REMARKS

The Examiner has objected to the drawings for various reasons. The drawings have been amended to remove the black stripe at the bottom of the figures and Fig. 6 has been amended to include the legend --Prior Art-- and change reference numeral "210" to --211-- to conform to the specification. The Examiner has also objected to the drawings for containing black and white photographs. Specifically, it appears that the Examiner is objecting to Fig. 5. A new proposed Fig. 5 will be filed under a separate transmittal.

FIG. 6 PRIOR ART

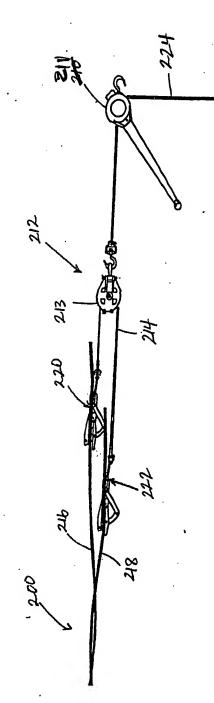
The Examiner asserts that the admitted prior art shown in Fig. 6 discloses the invention as claimed in claim 1. The Examiner's rejection is respectfully traversed. As described in the specification and more fully explained above, the invention shown in Fig. 6 is used to even the tension in T-2 cables <u>after</u> they have been pulled through stringing rollers (see Background of Invention). This is because the tension evening device shown in Fig. 6 is too large to be pulled through the stringing rollers.

The present invention reduces the size of the tension evening device so that it is attached to the T-2 cable <u>prior</u> to being pulled through the stringing rollers so that constant adjustment in the tension of the cable is performed (see Summary and Objects of the Invention, para. 1). Claim 1 recites a method where the tension evening device is attached to an electric cable and is subsequently pulled through support blocks. This is not disclosed by the admitted prior art, nor any of the other references cited by the Examiner. Therefore, it is believed that claims 1-5 are allowable.
